Project	IEEE 802.16 Broadband Wireless Access Working Group < http://ieee802.org/16 >	
Title	Solutions for some AIs in last meeting.	
Date Submitted	2007-03-11	
Source(s)	Wu Xuyong, Huawei	Voice: +86-755-28973547 Fax: wuxuyong@huawei.com ,
Re:	IEEE 802.16-07/010: IEEE 802.16 Working Group Letter Ballot Recirc #24a: Announcement (2007-02-01)	
Abstract	Following AIs assigned in last meeting.	
Purpose	To consolidate the 16h draft.	
Notice	This document has been prepared to assist IEEE 802.16. It is offered as a basis for discussion and is not binding on the contributing individual(s) or organization(s). The material in this document is subject to change in form and content after further study. The contributor(s) reserve(s) the right to add, amend or withdraw material contained herein.	
Release	The contributor grants a free, irrevocable license to the IEEE to incorporate material contained in this contribution, and any modifications thereof, in the creation of an IEEE Standards publication; to copyright in the IEEE's name any IEEE Standards publication even though it may include portions of this contribution; and at the IEEE's sole discretion to permit others to reproduce in whole or i

531a) change figure h46 as follows(only to move the shared part to the front of the 4 frame.):

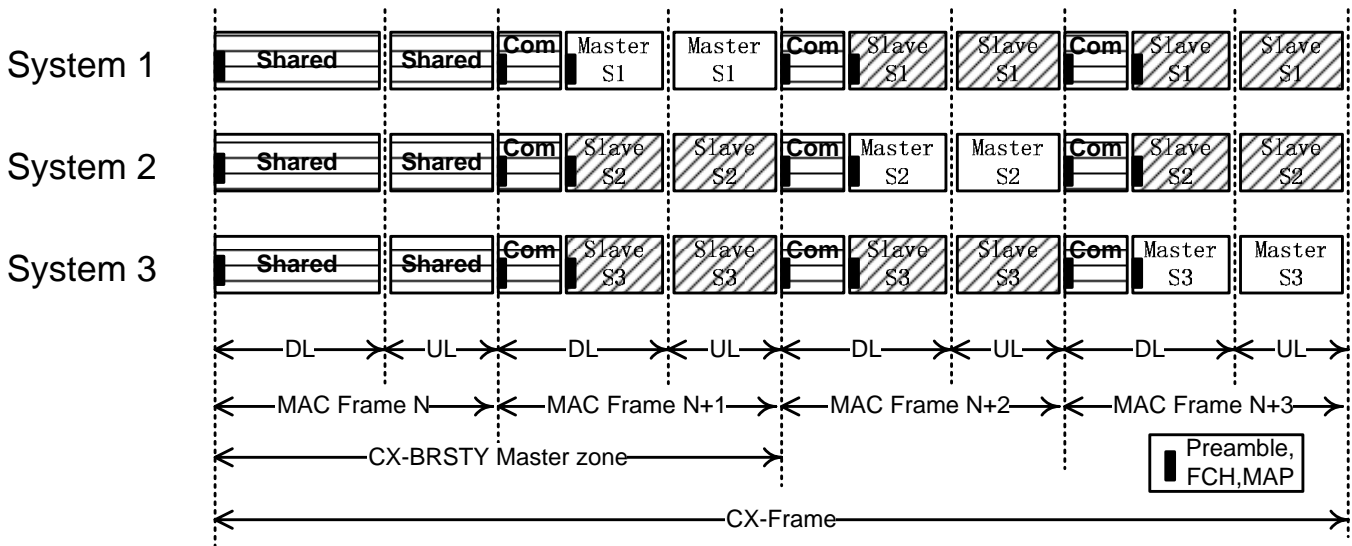
Comment: [531] By Phillip Barber

What if a BS is a part of more than one neighborhood or community? part of three neighborhoods? four? nine? How can the available solution methodologies cope with the complexity of such decision making?

Discussion: There is some discussion within Mariana's AIs, and some reply is relating to this topic, by the proposal of following frame structure, we limited only up to 3 systems within the neighborhood to share the radio resource in one channel.

Resolution: *We have limit the number of subframes to three in one working channel to allow the coexistence within neighborhood.*
